93-B-5 Harrington Ave., Long Island

May 11, 1971

Building permit to construct 1-story cottage 32' x 20' is being issued subject to plans received with the application and in compliance with Building Code restrictions as follows:

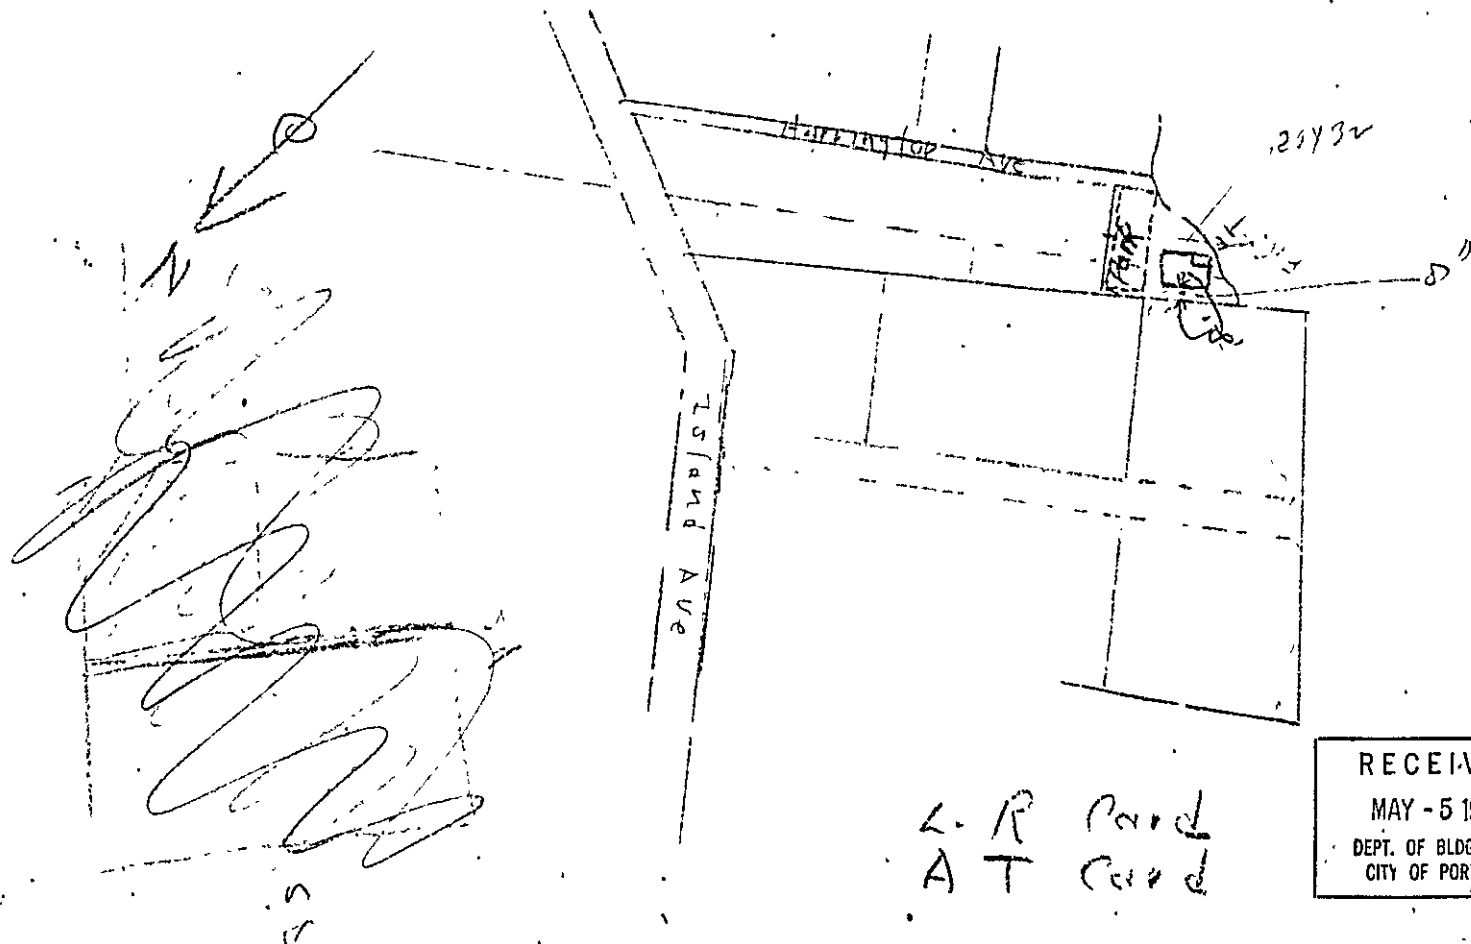
1. Sills on the side of this cottage called east and west on the plans, do not figure out. Sills need to be solid 4x8" members on spans of not more than 6' on the sides. The spacing of the sonotubes on the gable ends are adequate.

2. Girders on an 8' span do not figure out. They need to be spaced not more than 6' o.c's.

I have suggested spacing 6' o. c. on the girder and on the sills on the side instead of 8' as you show so that I could issue this permit for you. If, however, you desire to provide larger members instead let us know what these will be so we can check to see if they will support both dead and live load for the span you desire.
